# DEPARTMENT OF TRANSPORTATION

## National Highway Traffic Safety Administration

## Visual-Manual NHTSA Driver Distraction Guidelines

## For In-Vehicle Electronic Devices

**Figure 2: Drawing of Slide Presented by Toyota at NHTSA Technical Workshop**[136]

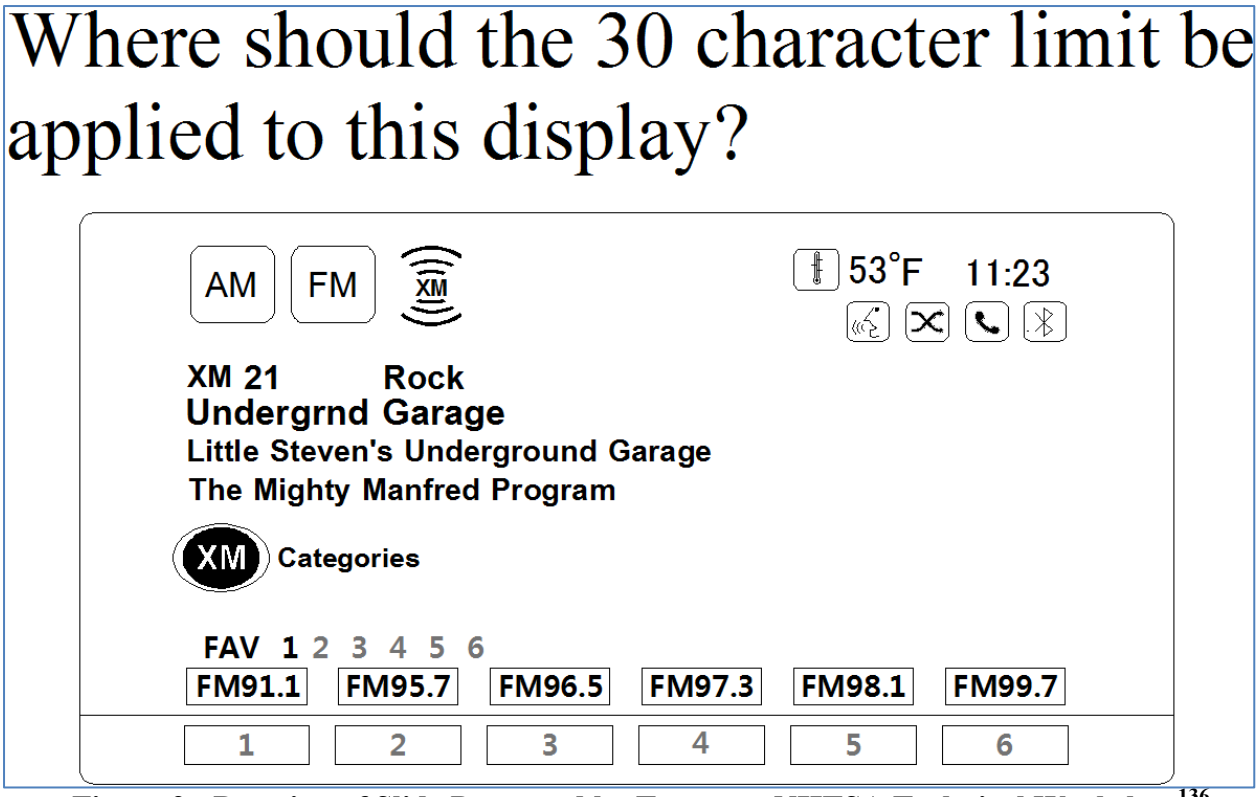
During the March 23, 2012 Technical Workshop on NHTSA's proposed Driver Distraction Guidelines, Mr. James Foley of Toyota showed a slide picturing a contemporary radio display showing several lines of text indicating satellite radio station program information (See Figure 2 below). He then asked:

Mr. Foley then pointed out that the information conveyed by this display is easily grasped and that drivers do not have to read each individual letter to understand what is being transmitted by this display.
